UNITED STATES PATENT AND TRADEMARK OFFICE

APPLICATION NO.	FILING DATE	FIRST NAMED INVENTOR	ATTORNEY DOCKET NO.	CONFIRMATION NO.
10/686,655	10/17/2003	Wen-Hai Tsao		1768

Office Action Summary	Application No. 10/686,655	Applicant(s) TSAO, WEN-HAI	
	Examiner George Nguyen	Art Unit 3723

DETAILED ACTION

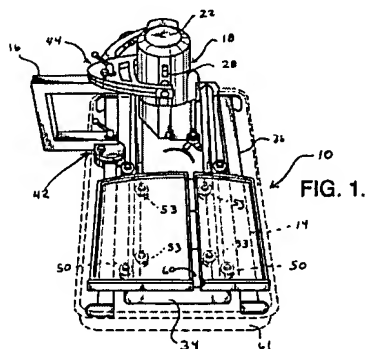
1. The specification is objected to as failing to provide proper antecedent basis for the claimed subject matter. See 37 CFR 1.75(d)(1) and MPEP § 608.01(o). Correction of the following is required: the limitations of “a second protrudent screw hole on the other side” is not clearly described in the specification. Is the tubular screw hole 53 considered the second protrudent screw hole?

With reference to Figure 2, Sigetich et al.'4,428,159 discloses portable, direct drive abrasive saw having a saw support 21 at the end of frame 13 adjacent end member 15b.

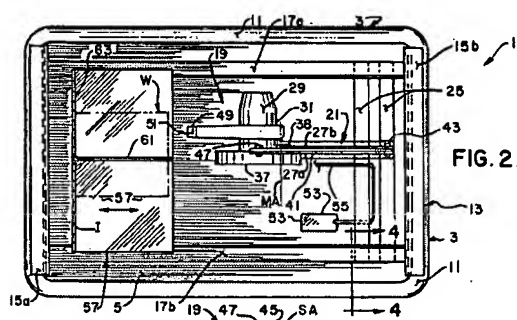
Further, portable saw 1 of the present invention includes a unitary, direct drive, rotary saw assembly, as generally indicated at 19, fixedly positioned by frame 13. The frame includes a saw support, as generally indicated at 21, at the end of the frame adjacent end member 15b. Saw support 21 is shown to comprise a pair of vertical supports 23 spaced apart from one another and at each side of the frame secured (e.g., welded) to respective rail members 17a, 17b and extending vertically above the upper edge of the vertical flange of the rail members. Horizontal support members 25 extend transversely of the frame from the upper end of one vertical support member 23 to the upper end of a corresponding vertical support member on the opposite side of the frame. Again, vertical members 23 and horizontal members 25 are of angle iron construction and the horizontal transverse members 25 are oriented so as to have their upper flanges in generally horizontal position and vertical flanges extending downwardly with the horizontal upper flanges constituting a generally planar mounting surface 45.

However, the prior art of record fails to provide or suggest the specific limitations of the specific limitations of "said second outer longitudinal bar ... on the other side" in the combination as claimed in claim 1.
